Byron Station, Units 1 and 2
Facility Operating License Nos. NPF-37 and NPF-66
NRC Docket Nos. STN 50-454 and STN 50-455

Subject: Initial License Examinations Post-Examination Review

**Byron Station Staff/Applicant Comments
Regarding the NRC Initial Written Examination**

FIGURE HT-7-22c RCP B TRIP MANUAL RODS

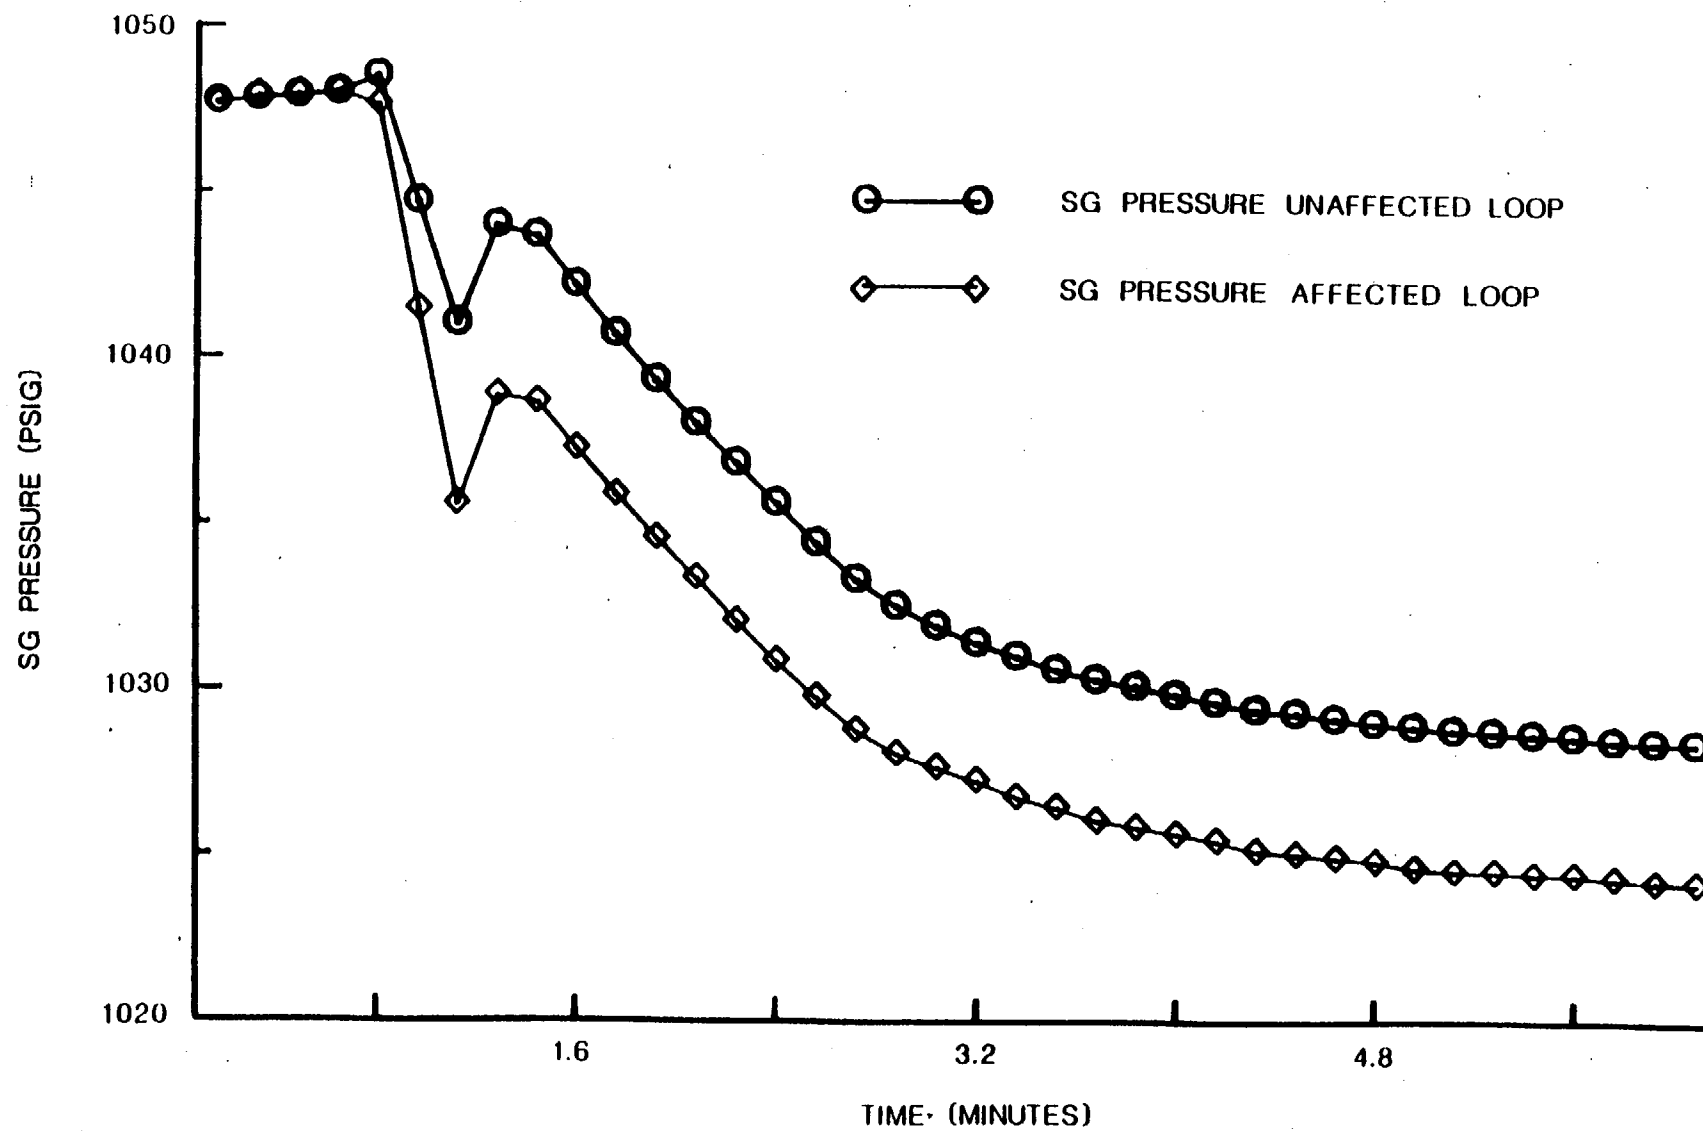
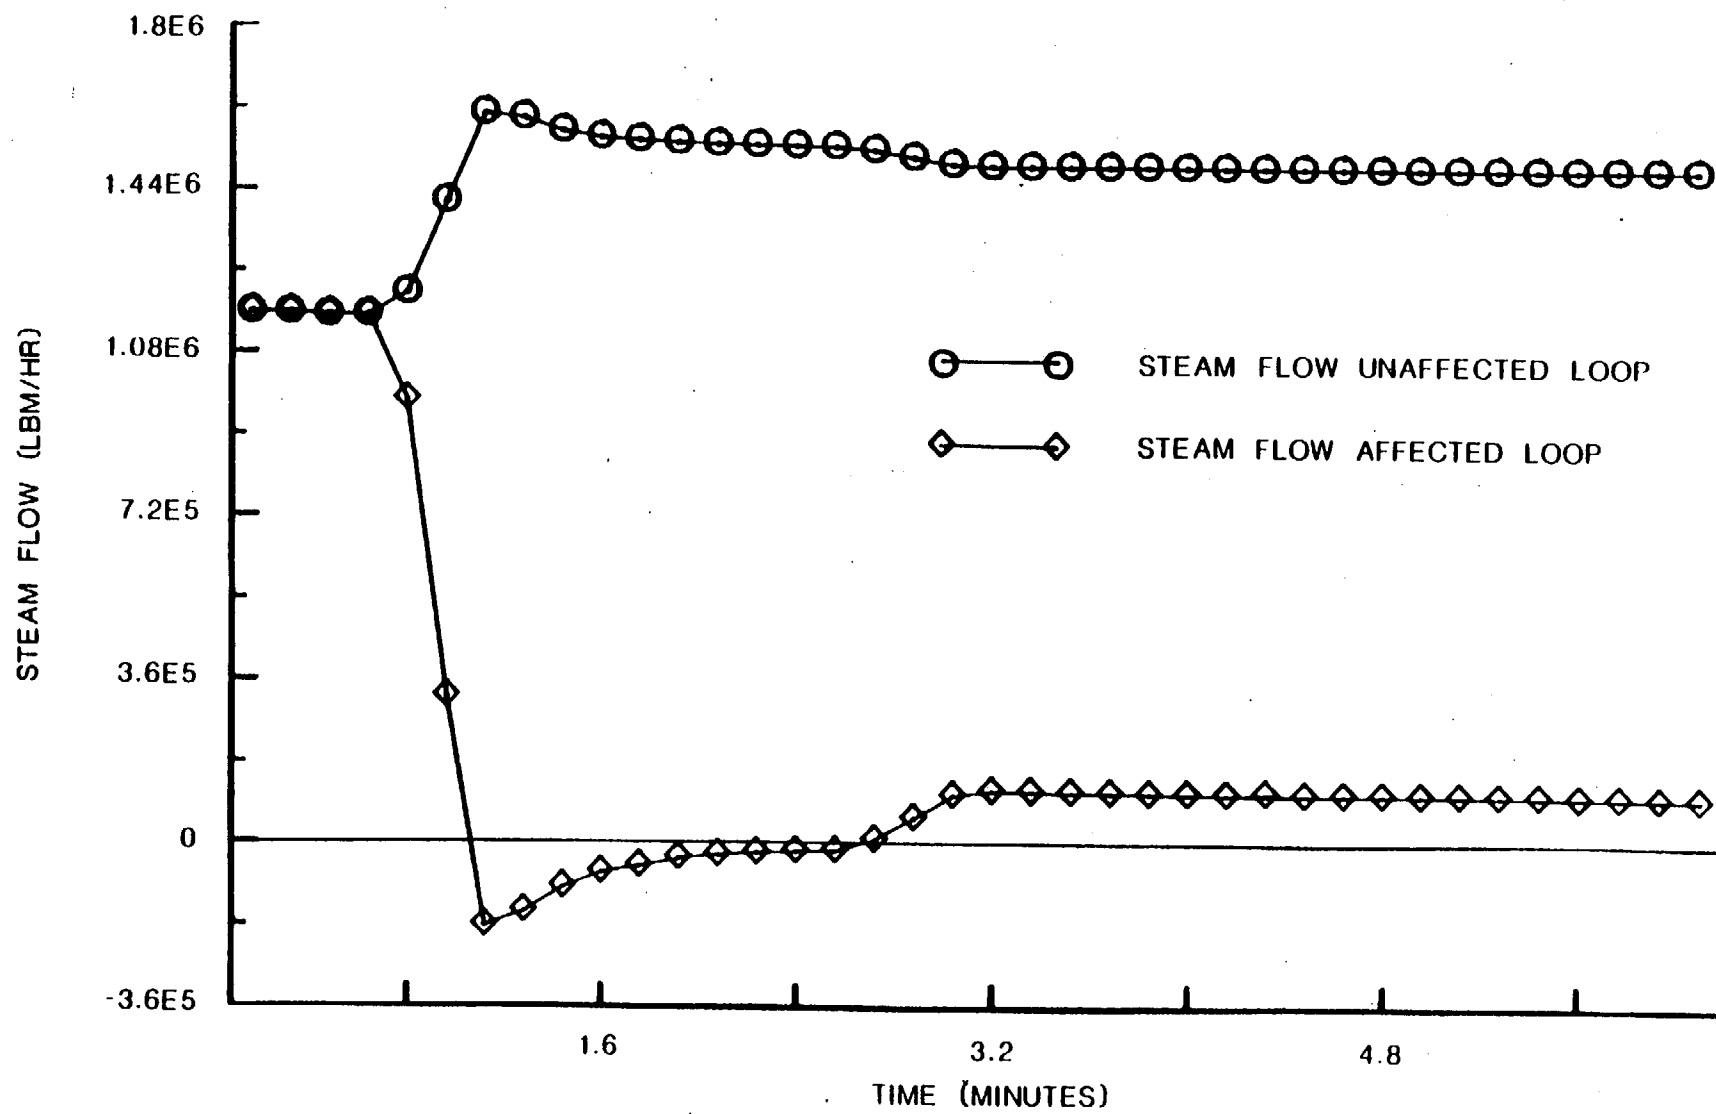
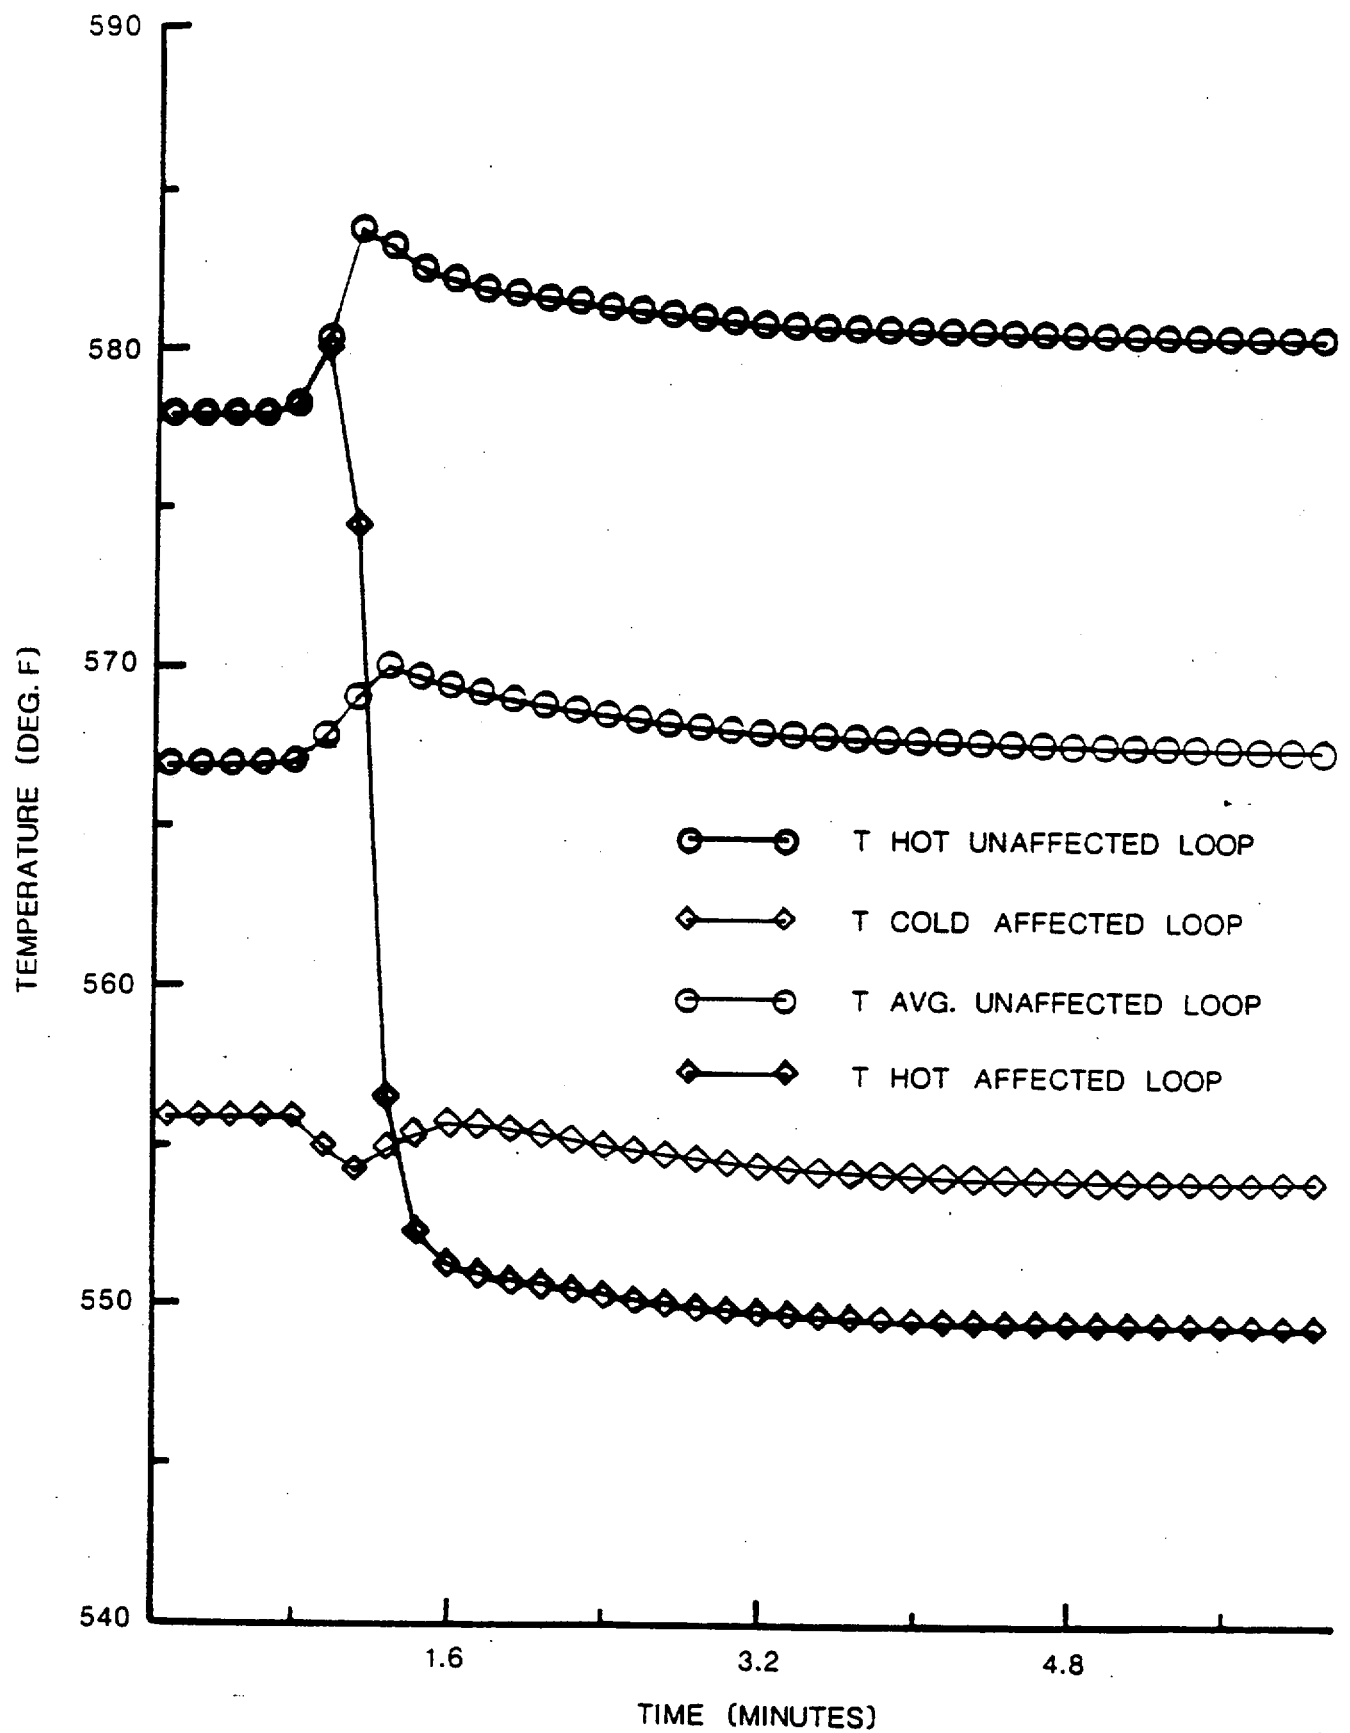
Comment: Distractor D is the correct answer for this question. The question asks for the initial response of the unit due to a trip of a reactor coolant pump. Hot leg temperature in the unaffected loops will increase since the same reactor heat input is being absorbed by less total core flow. This causes Tavg to initially increase.

Resolution: Accept distractor D as the only correct answer.
